Village of Bayside
9075 N. Regent Rd.
Architectural Review Committee Meeting
August 19, 2019
Village Board Room, 6:00pm

**ARCHITECTURAL REVIEW COMMITTEE
AGENDA**

Attention:
Village of Bayside, WI
Architecture Review Committee

PROJECT/SITE OWNER: Andrew Smith PROJECT ADDRESS: 8755 N Greenvale Road	PROJECT SUMMARY: New cedar deck over existing rear patio.
--	--

Proposed Site Views

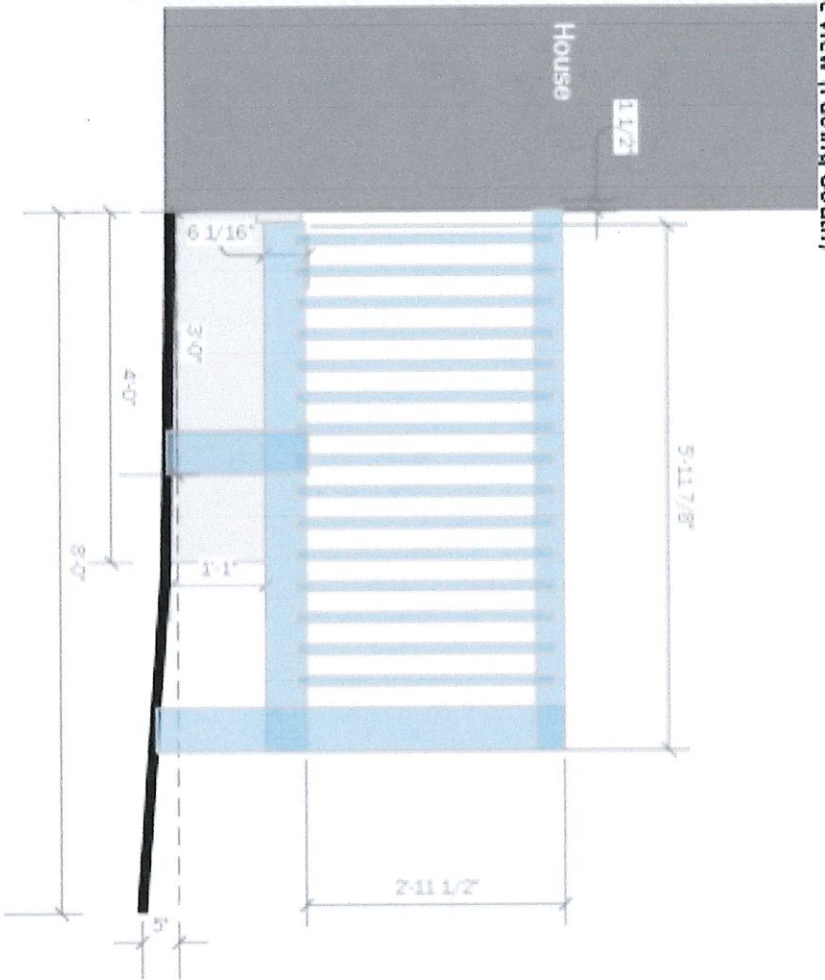
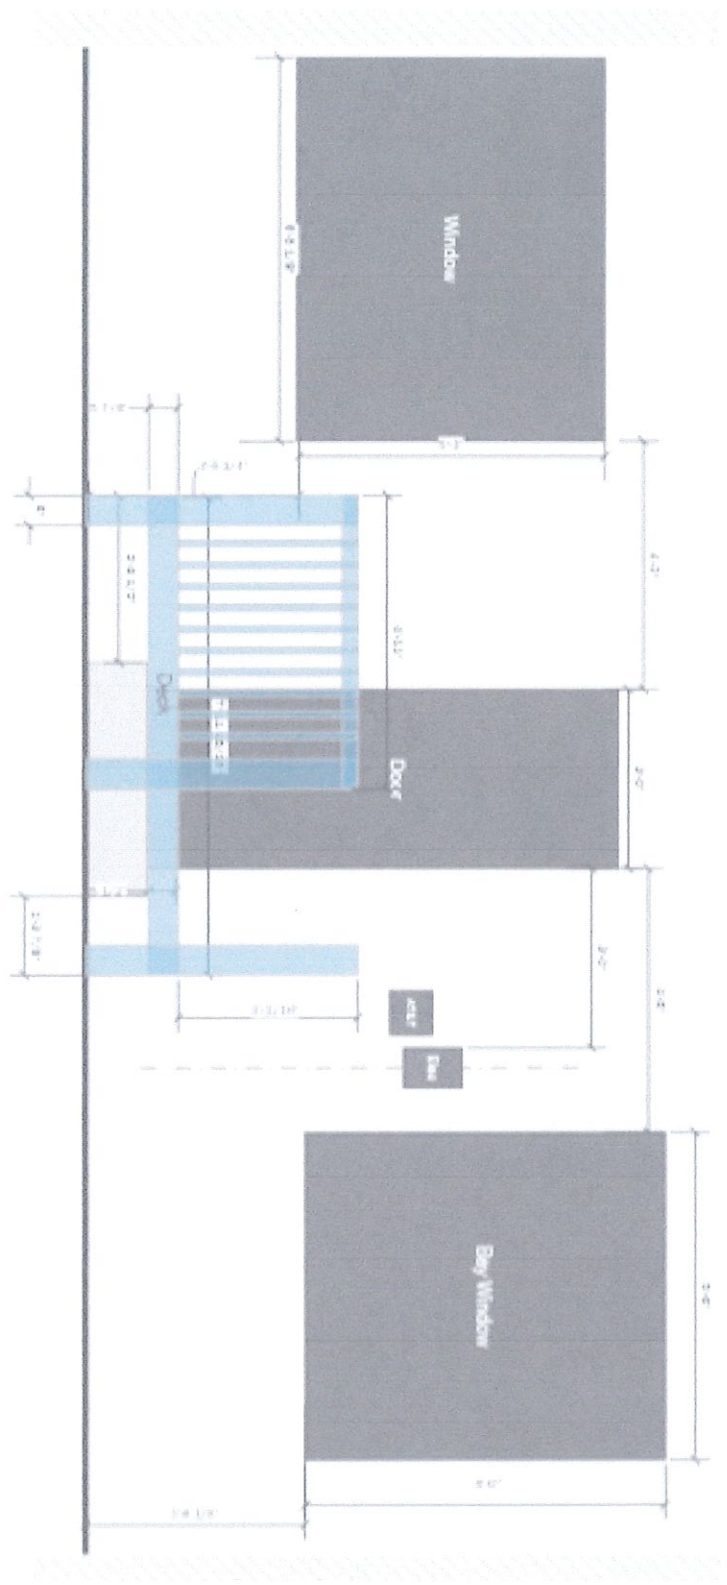
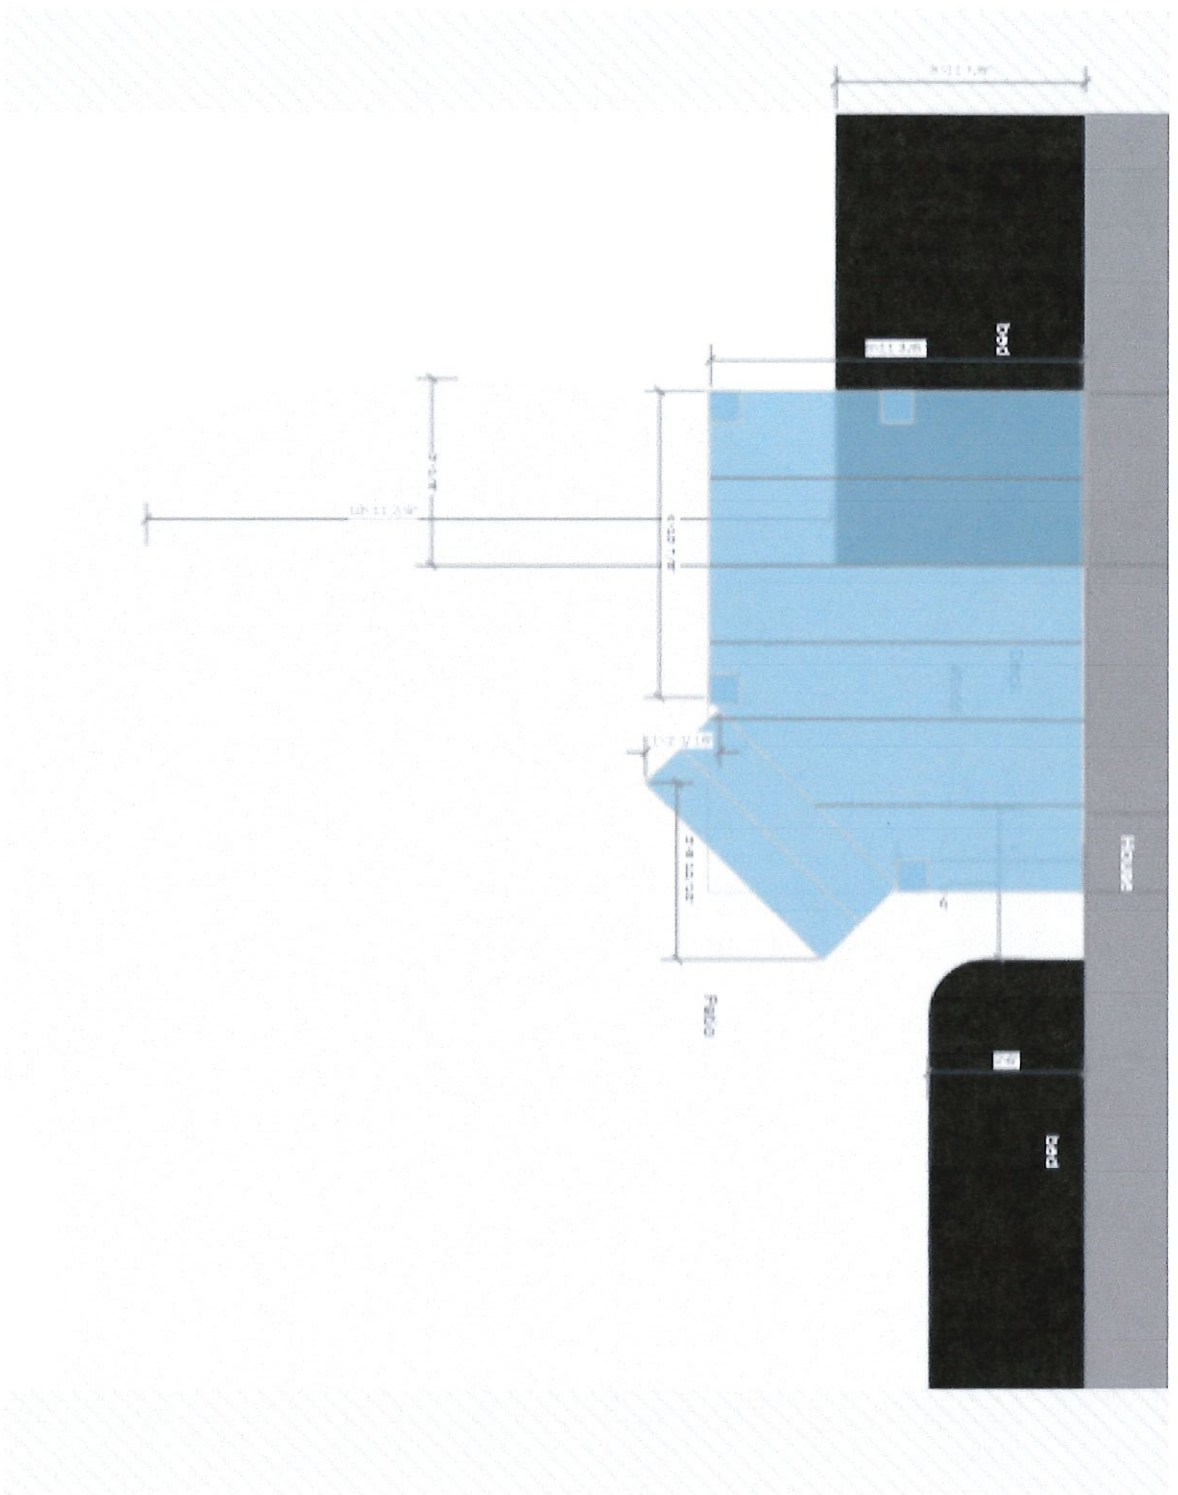
SPS 321.225 - Deck structure shall be protected against frost. The deck drawings do not show new pier supports that extend to the frost line or an alternative frost protection system. Building the new deck on the existing patio does not provide adequate frost protection. Revised details will be required prior to the issuance of a building permit.

SKETCH

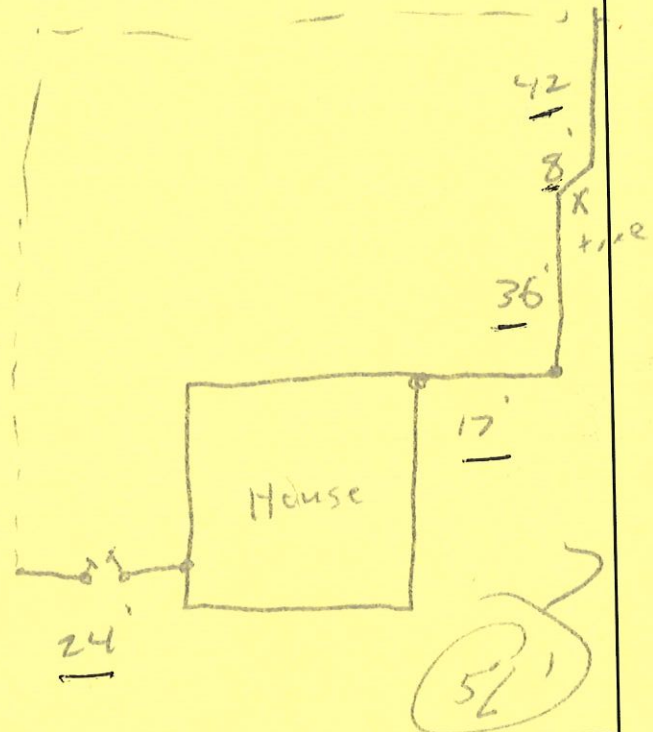
127' of new 4ft tall, cedar, dog-eared fence,
25% open design located on side yards.
New fence will connect to and match
existing fencing.

PROPOSED FENCE TYPE AND LENGTH COMPLY

- Indicates where the fencing* will be installed on the property at 8944 N. Navajo Rd. (*4ft wood pickets)
- Indicates where the front and rear-facing gates will be installed.

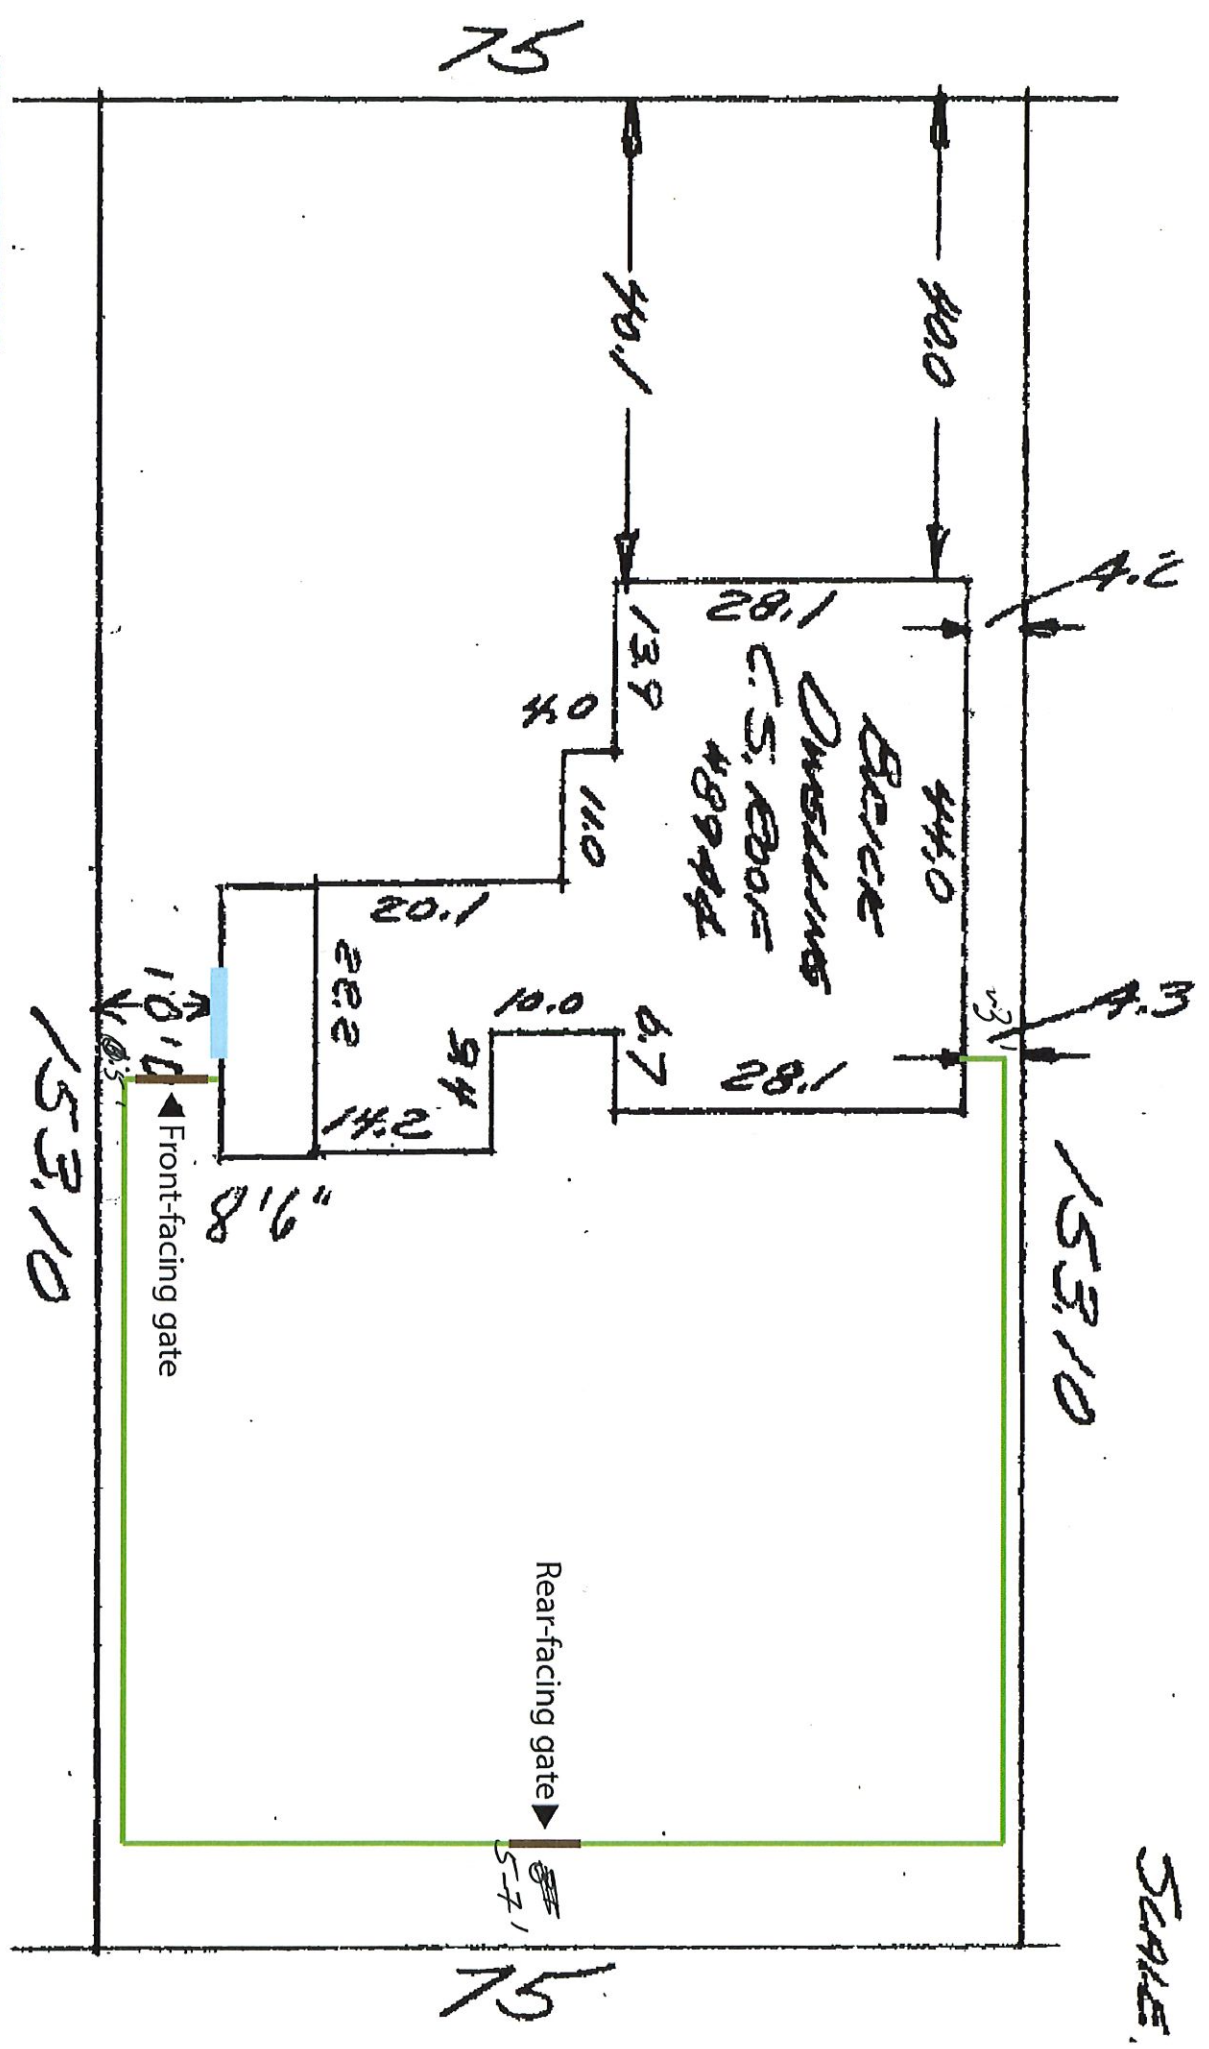
Split rail fence is more than 50% open. Therefore, the design complies with village code requirements below.

PROPOSED FENCE TYPE AND LENGTH COMPLY
